Date: November 10, 2022
To: Planning Board
From: Camille Pattison, NRPC Assistant Director
Subject: SP2022-08 Sooner Transportation LLC, for the property located at Tax Map 12, Lot 11, 754-756 Elm Street (Horseless Carriage Site). Public Hearing for a Major Site Plan Application to construct a two-story, 10,320 sf. auto sales and repair facility with associated parking, stormwater management/drainage, landscaping, and lighting improvements on the subject property located in the Commercial ‘C’ Zoning District and West Elm Overlay District.

Attached, please find a revised submittal package, including the Elm Street Gateway District justification, revised waiver requests, revised site plan (revision date 11/2/22) and updated building concept, from the applicant’s engineer, Bedford Design Consultants.

**Re: Sooner Milford Site Plan (Tax Map 12, Lot 11) – 754 and 756 Elm Street
Site Plan Drainage Review**

TAX MAP 12 LOT 11
OVERVIEW & SITE PLAN
SOONER-MILFORD
 LOCATED AT:
754-756 ELM STREET
MILFORD, NEW HAMPSHIRE, 03055
 OWNER: LAND BARGE, LLC
 754-756 ELM STREET
 MILFORD, NH 03055
 APPLICANT: SOONER TRANSPORTATION LLC
 3 EXECUTIVE PARK DRIVE, SUITE 2016
 BEDFORD, NH 03110

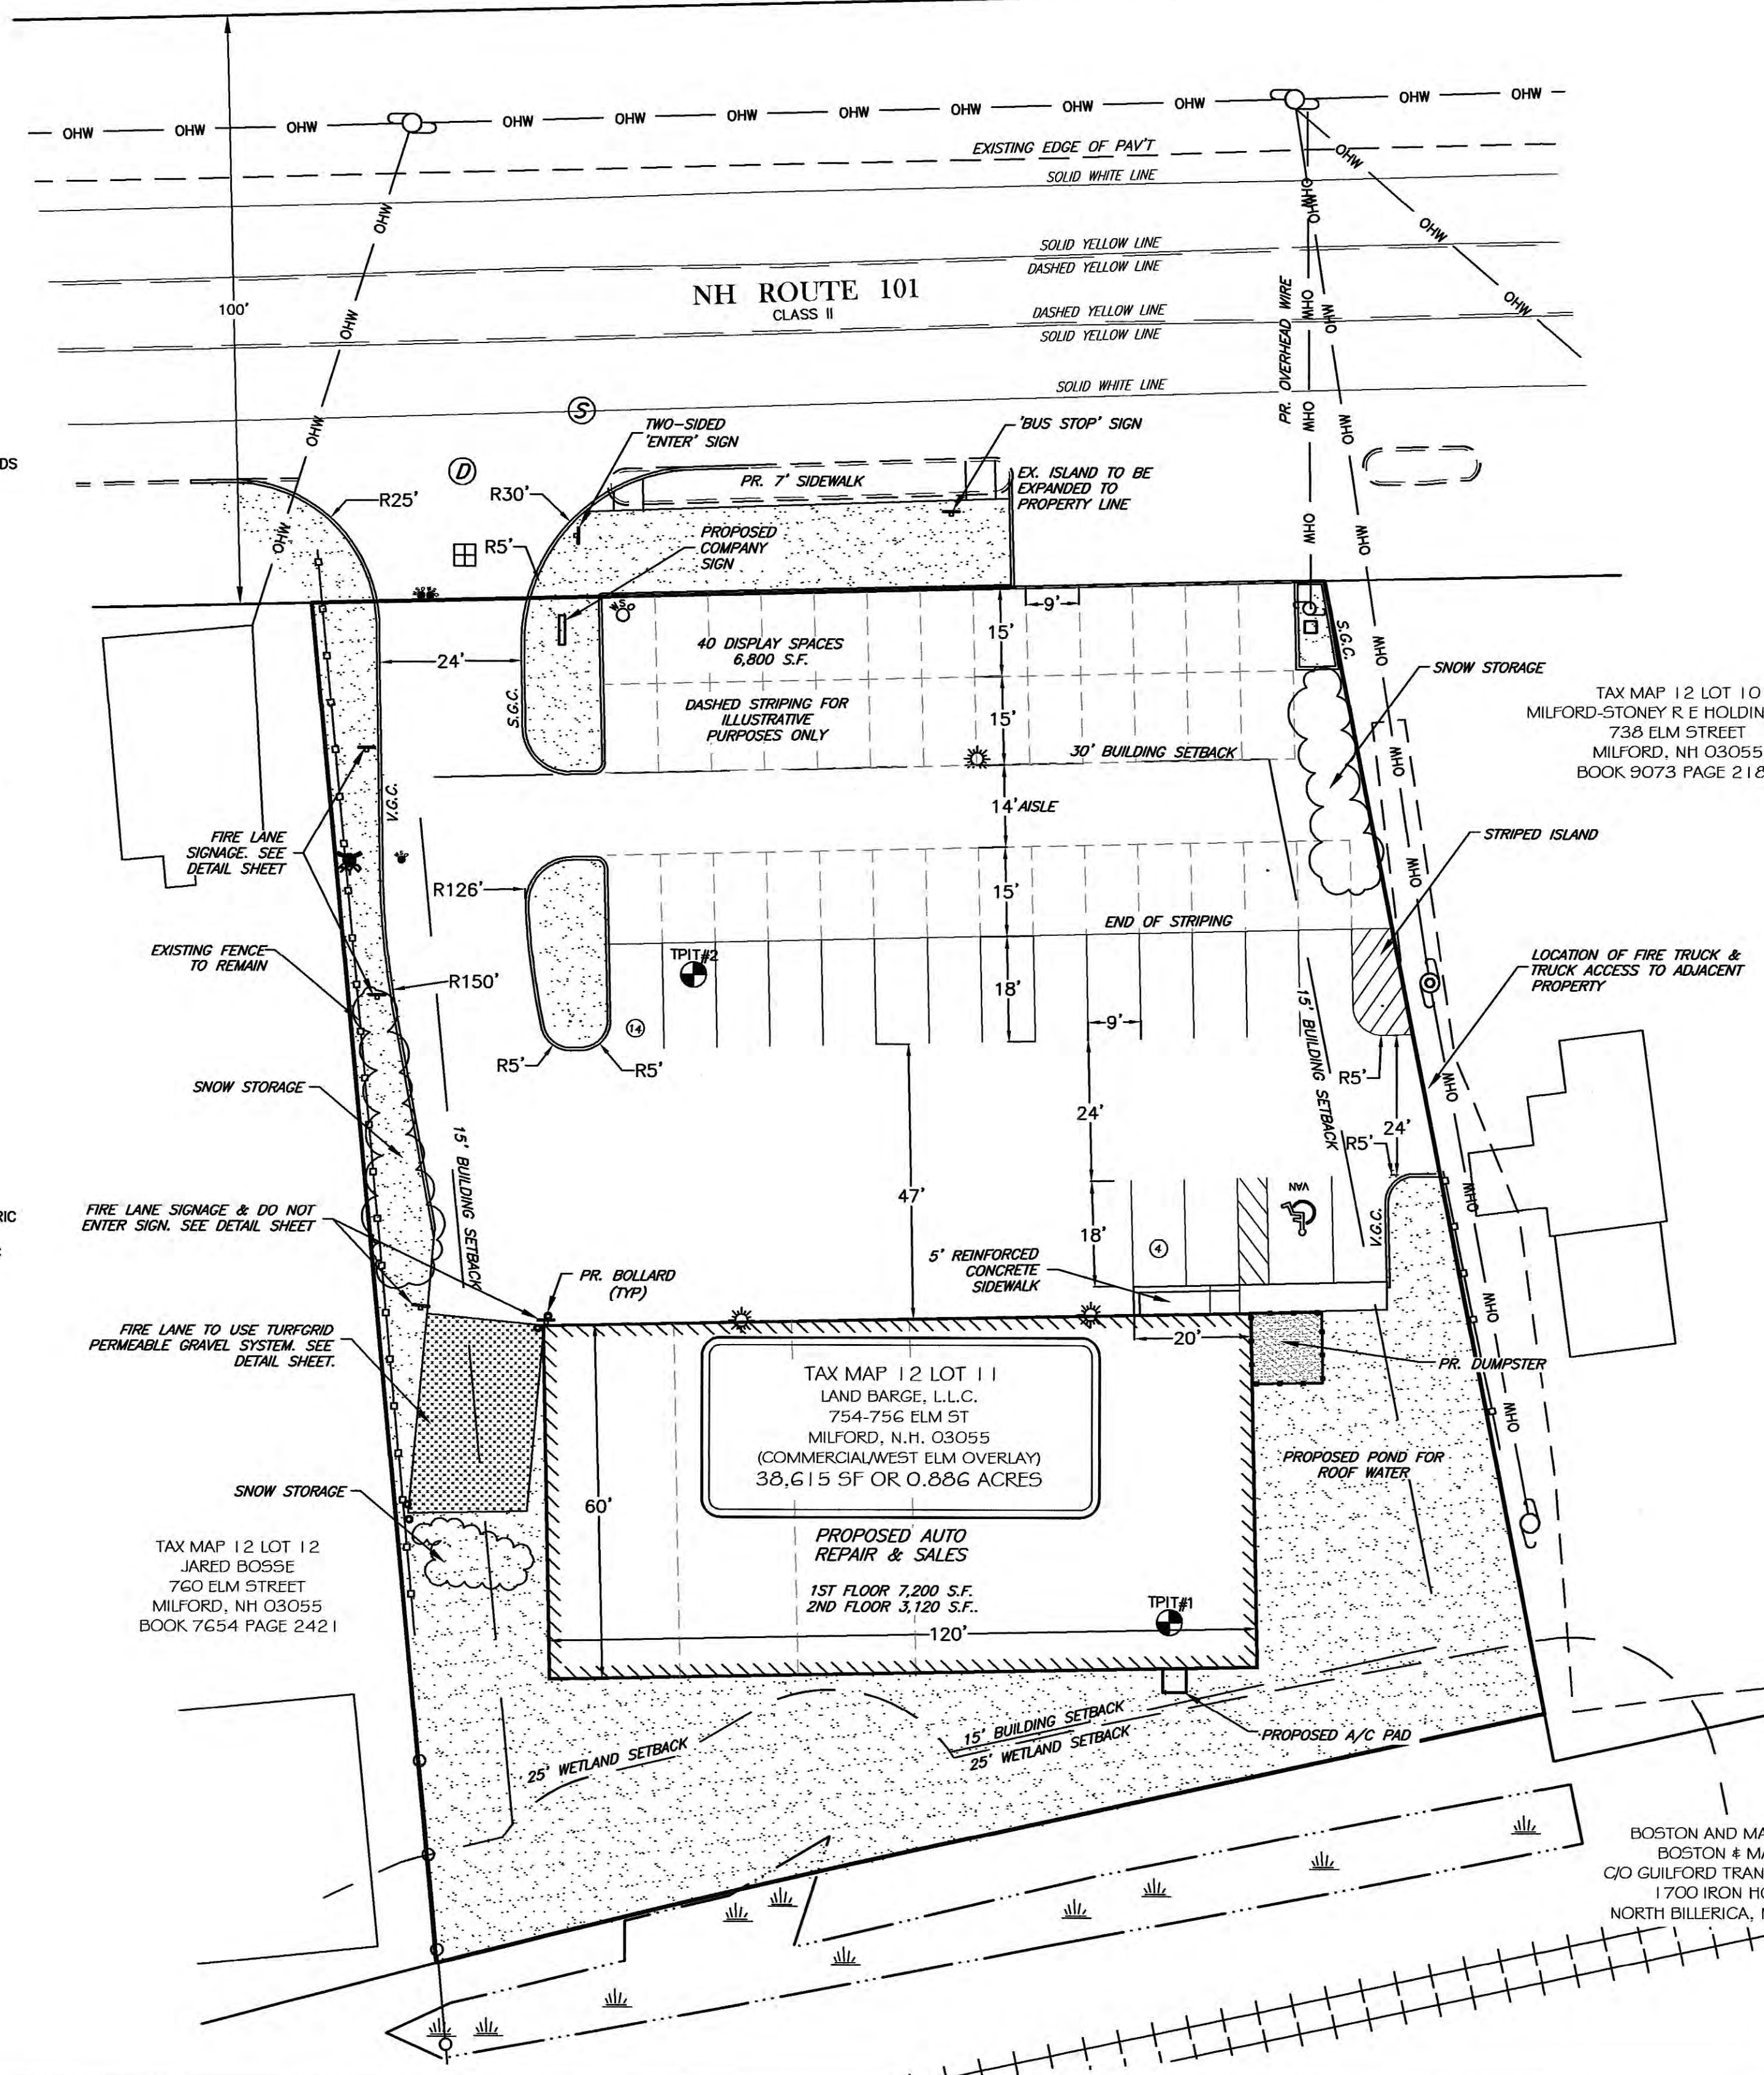
8. Sheet 1, Note 9 – Please update the site plan to include the existing and resulting open space calculations in the *Dimensional Regulations: Commercial* table. *Resolved*

11. Sheet 1 – Further as stated in Section 6.05.6.E, all off-street parking and loading or unloading spaces shall be at least ten feet (10’) from any public street right-of-way and shall be separated from such right-of-way by a granite curb and landscaping as required in 6.08 LANDSCAPING STANDARDS. The proposal require a waiver of these requirements.

12. Sheet 1 – The plan shows display parking space partially located off the property and within the State right-of-way. As stated in the Zoning Ordinance, Section 6.05.6.E, Parking and loading spaces shall be arranged so that cars will not back into public roads. The plan will need to be amended to relocate said parking spaces within the subject property at least 10 feet from the Elm Street public right-of-way. ***Now located within the site, but still requires a Waiver from Development Regulations Section 6.05.6.E for parking within 10' of the Right of Way***

13. Sheet 1 - The applicant should explain the internal circulation, access/egress patterns for the 40 display vehicles. At a minimum, the plan should be revised to include the appropriate aisle widths between the rows of display vehicle parking. *One row of cars has been removed and a 14' aisle added. Applicant has provided an internal circulation pattern for trailer trucks. Resolved*

14. Sheet 1 – Staff questions if the adequate snow storage areas have been provided. A note should be added to the plan stating that snow shall be removed to an offsite location using best management practices. *Resolved see not 16 on Sheet 1.*

FIRE TRUCK TURNING PLAN
SCALE = 1" = 40'

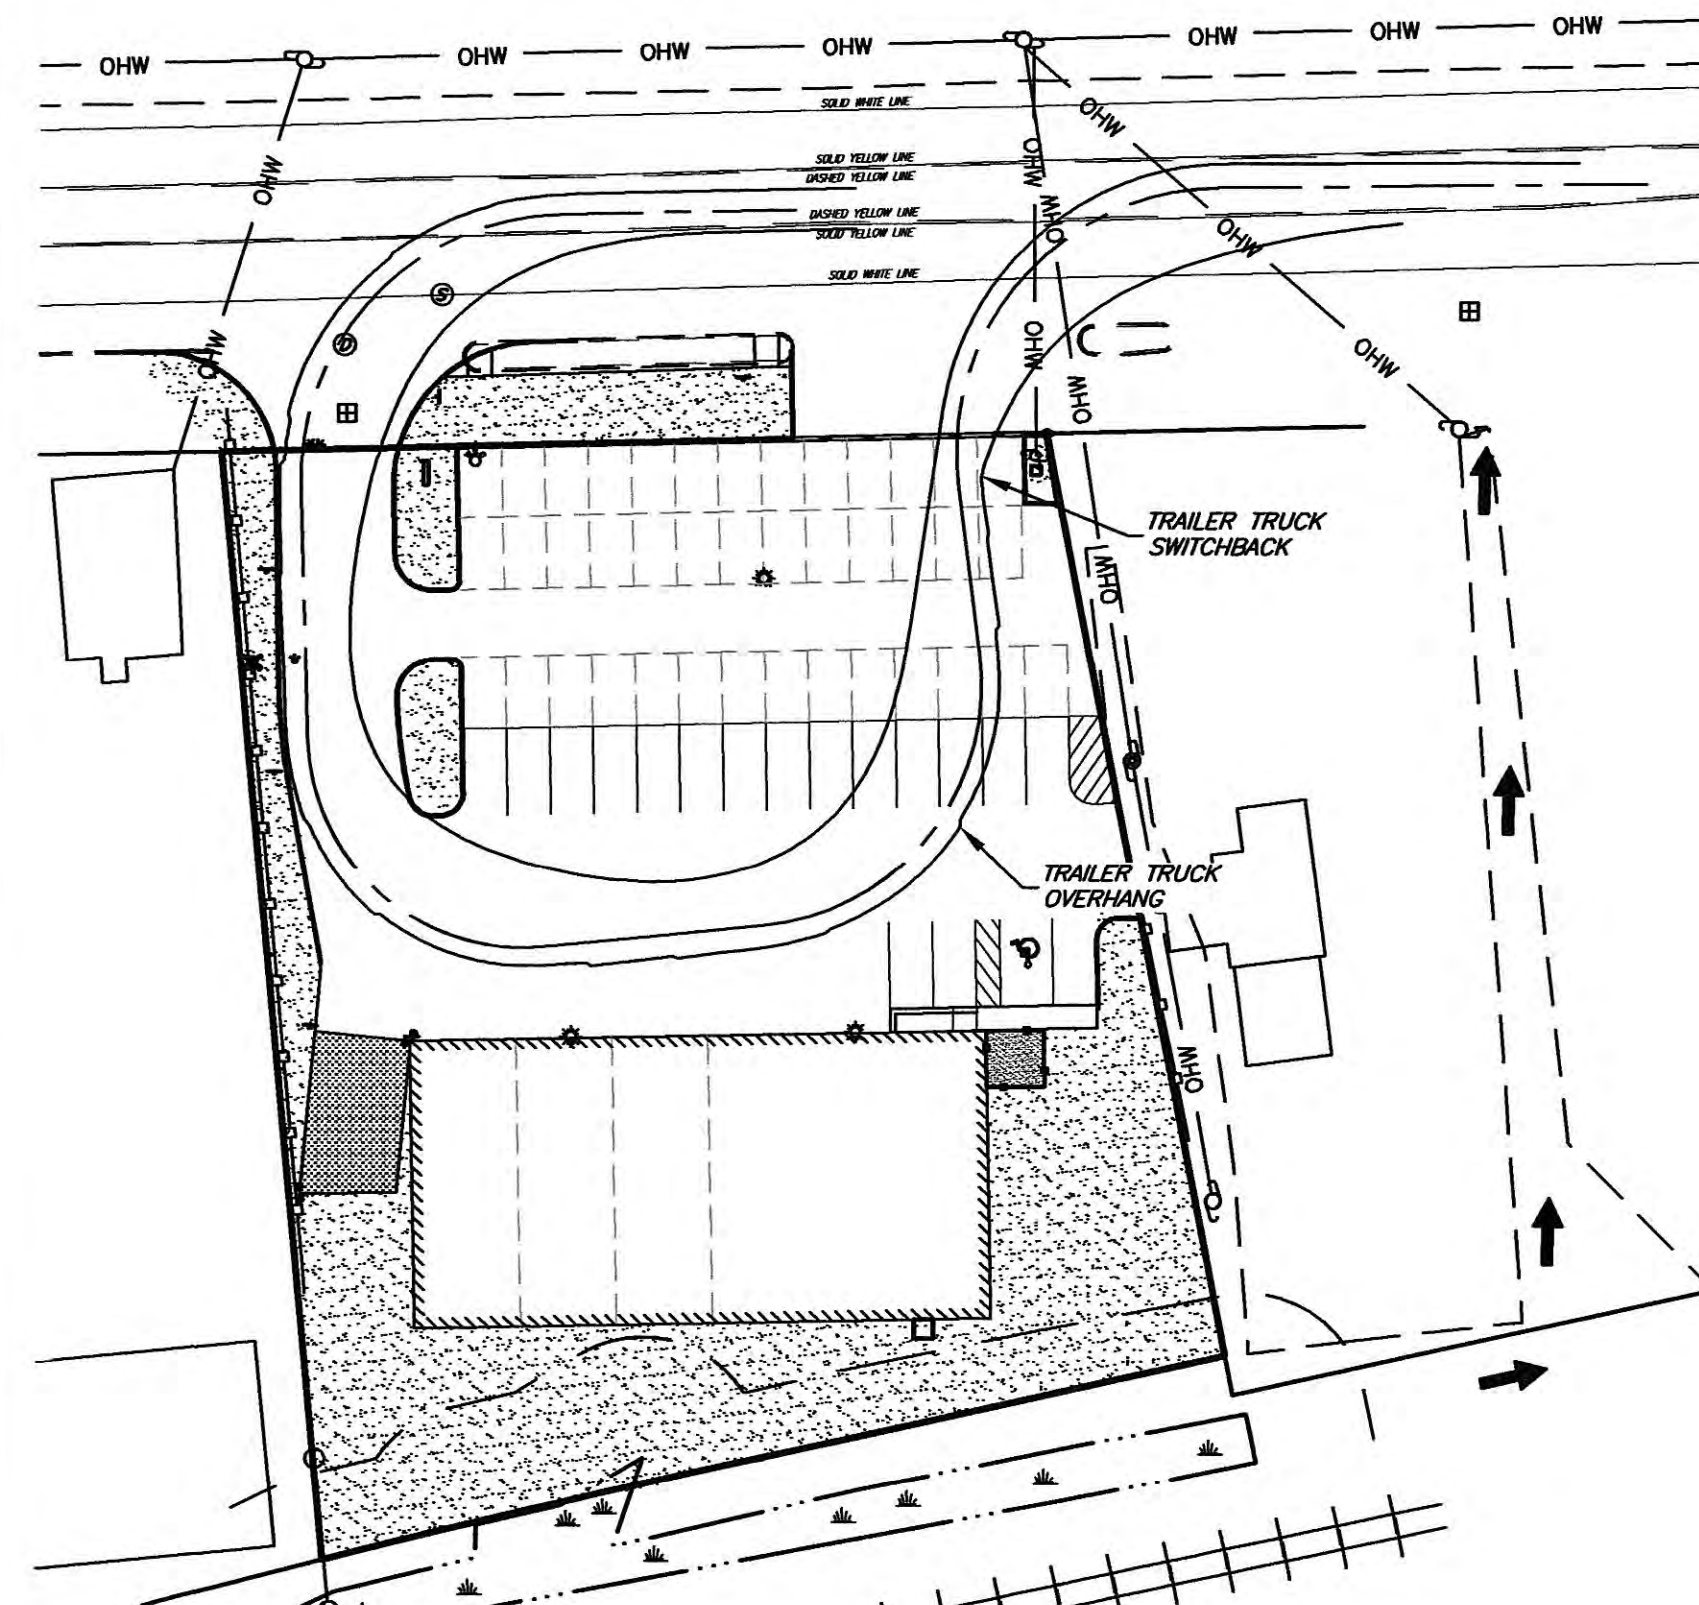
7. The engineer must design the fire department access to accommodate our ladder truck weight, approach/departure angles, and turning radius. Specifications available from MFD upon request. – *The applicant has worked with the Fire Department to design an acceptable on site turn around area that will accommodate fire trucks. On November 4, 2022, the Milford Fire Department approved the plans entitled 'Sooner Milford Site Plan', with a revision date of November 2, 2022. If the design is not further modified, then these plans will be acceptable for the site portion of our building permit review, but if any changes are made Milford FD would need to review a new set of drawings as part of building permit review when that time comes.*

**MILFORD, NH
FIRE LANE SIGN DETAIL**
NOT TO SCALE

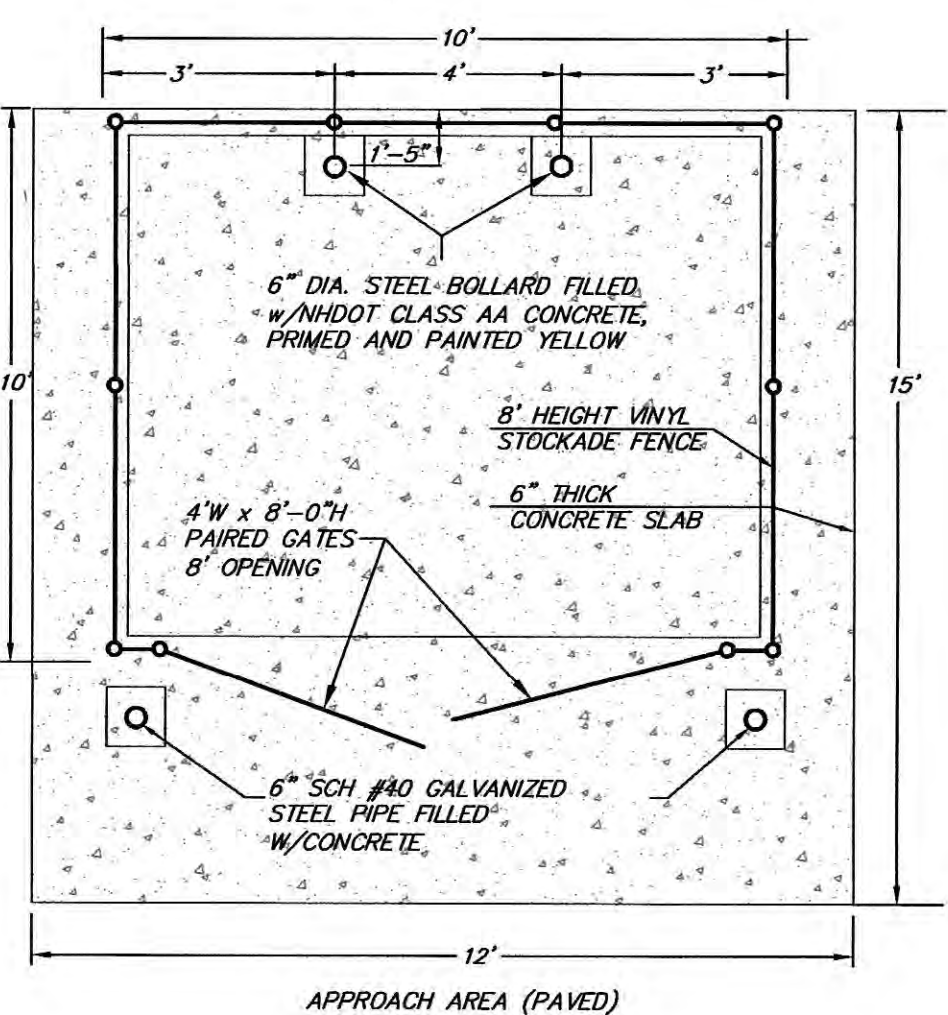
9. Fire lane markings will be required on the fire department access. – *Resolved and shown on sheet 11 dated November 2, 2022.*

DUMPSTER ENCLOSURE DETAIL
NOT TO SCALE

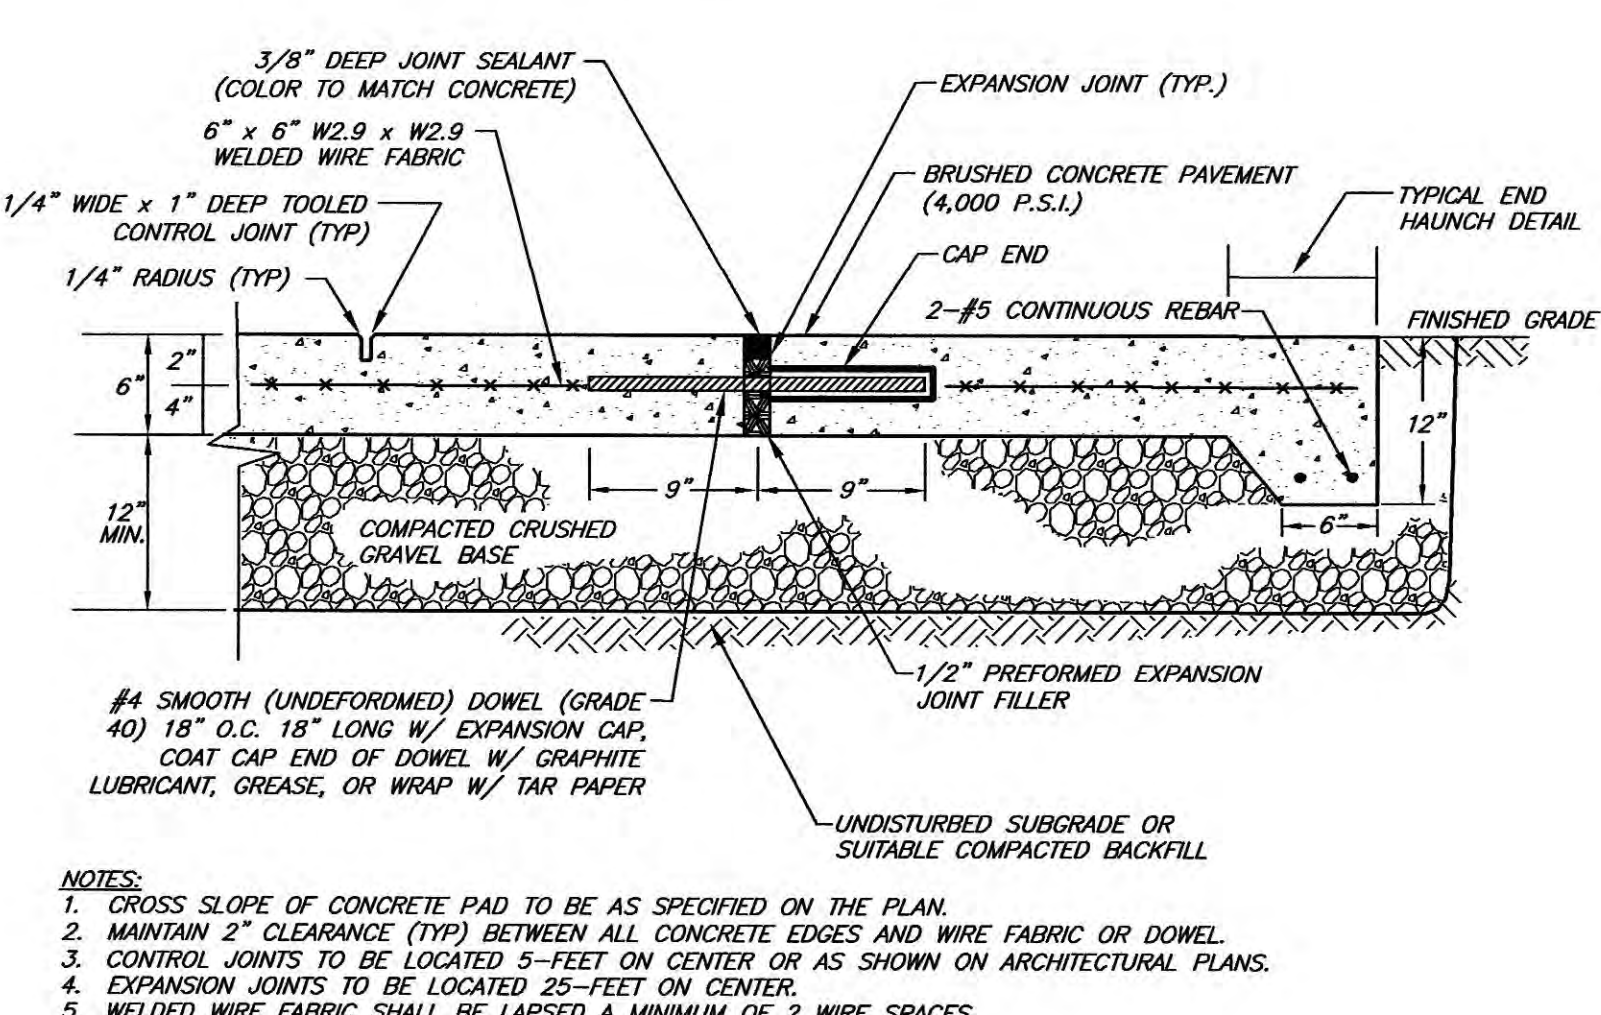
9. Please revise site plan to include all proposed signage for the project. *Resolved*
10. Sheets 1 and 10 – The site plan shows the proposed location of the dumpster and pad encircled by an 8’ stockade fence within the 15-foot westerly side dimensional setback. The proposed 8’ stockade fence and concrete pad are defined as structures in the Town’s Zoning Ordinance and such, would require a Special Exception by the Board of Adjustment for relief of this requirement. The alternative would be amending the plan and relocate the dumpster outside of the dimensional setback. *Resolved*
